## APPLICATION FOR PERMIT TO DRILL, DEEPEN, OR PLUG BACK

## SUNDRY NOTICES AND REPORTS ON WELLS

8. FARM OR LEASE NAME  
McDaniel "B"9. WELL NO.  
#1E10. FIELD OR WILDCAT NAME  
Basin Dakota  
Blanco Pict. Cliffs11. SEC., T., R., M., OR BLK. AND SURVEY OR AREA  
Section 17, T29N, R11W12. COUNTY OR PARISH  
San Juan13. STATE  
New Mexico

RE: McDaniel "B" #1E  
1620' FNL & 990' FWL  
Sec. 17, T29N, R11W  
San Juan County, NM

**NEW MEXICO OIL CONSERVATION COMMISSION  
WELL LOCATION AND ACREAGE DEDICATION PLAT**

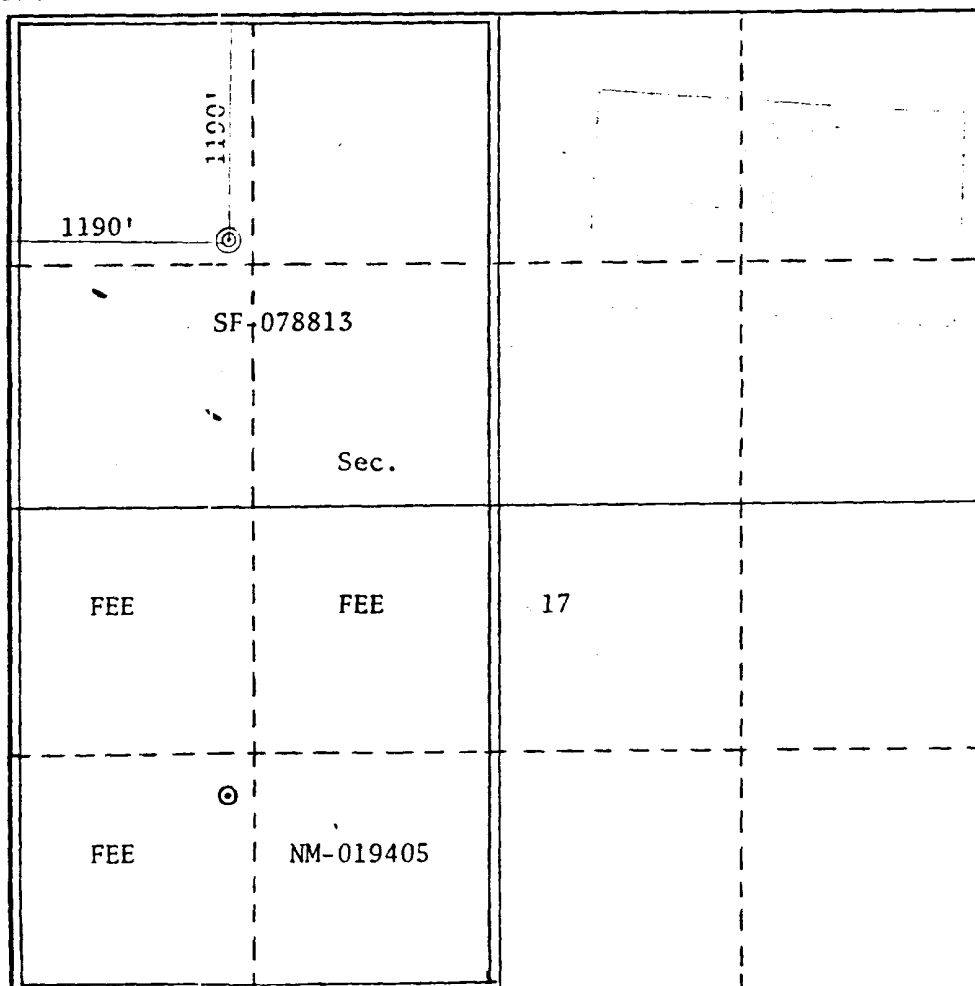
D ~~1620' FNL & 980' FNL~~ 1190 W / 1190 W

Southland Royalty Company proposes to re-stake the well site from  
1620' FNL & 980' FWL to 1190' FNL & 1190' FWL.

We, therefore, ask you to grant us permission to move the McDaniel "B" #1E from it's current position, as noted above, to the location selected for the Barnhart #2 which is 1190' FNL & 1190' FWL, Section 17, T29N, R11W, San Juan County, New Mexico.

Utilizing an existing location minimizes surface damage & is approved even though the location violates the 200' rule.  
March 12, 1980
